# LXT971A/972A PHY Transceivers

## Specification Update

*May 2002*

Order Number: **249354-007**

**Figure 1. Ordering Information - Sample**

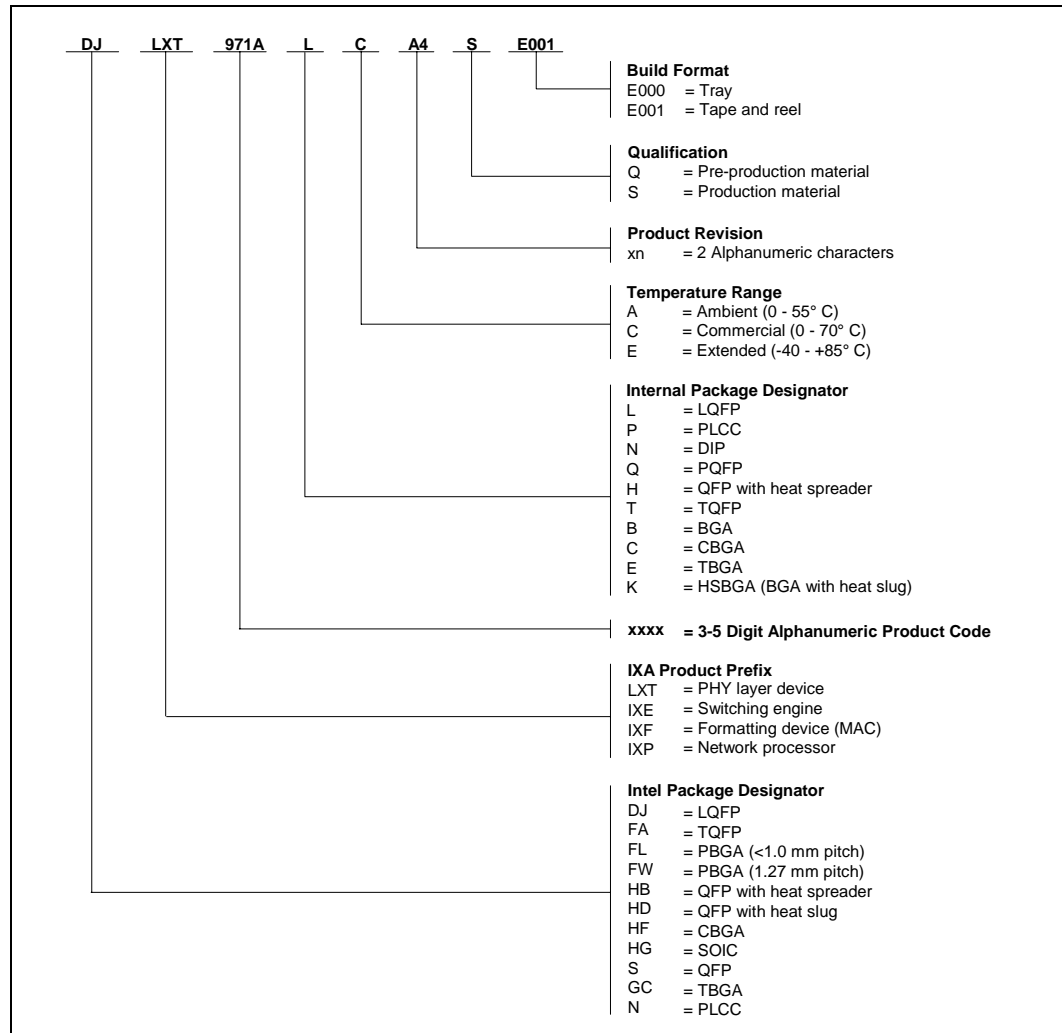
# Documentation Changes

**Table 3. Product Information**
